Re: Permit Number: SPRRN220319
Spacing and Notching of Corridor Wall Studs

STEAMBOAT HOTEL AND LODGE STUD REPAIR DETAIL HOTEL 3195 SOUTH LINCOLN STEAMBOAT SPRINGS, COLORADO 80477	DATE	1-11-23	 ALPENGLOW ENGINEERING SOLUTIONS, INC. Consulting Structural Engineers	PROJECT	22-050	SHEET S-1 1 OF 1
	DRAWN	BFS		CHECKED	BFS	
	FILE			SCALE	NOT TO SCALE

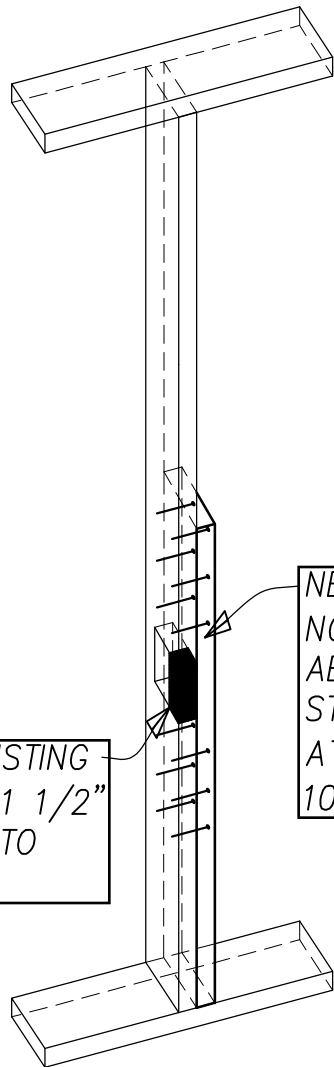
Several of the wood studs in the main level corridor were notched for a 2 3/8" diameter electrical conduit. The notch for the conduit was approximately 4 1/2" tall and 4" deep and repairs are required for the studs to safely support the imposed loading.

Repairs should consist of adding a 1 1/2"x 1 1/2" wood filler piece in the front of the notched stud and sistering a new partial stud to the existing stud. The new stud should run from the bottom plate and extend a minimum of 8" above the notch. The new stud should be attached to existing stud w/ (6) 10d nails above and below the notch (see attached drawing).

INFILL FRONT OF EXISTING NOTCH W/ 1 1/2" x 1 1/2" WOOD FILLER, GLUE TO ADDED STUD

NEW STUD SISTERED TO EXISTING NOTCHED STUD, EXTEND MIN. 8" ABOVE NOTCH, NOTCH BACK OF STUD TIGHT FOR CONDUIT, AND ATTACH TO EXISTING STUD W/ (6) 10d's ABOVE AND BELOW NOTCH
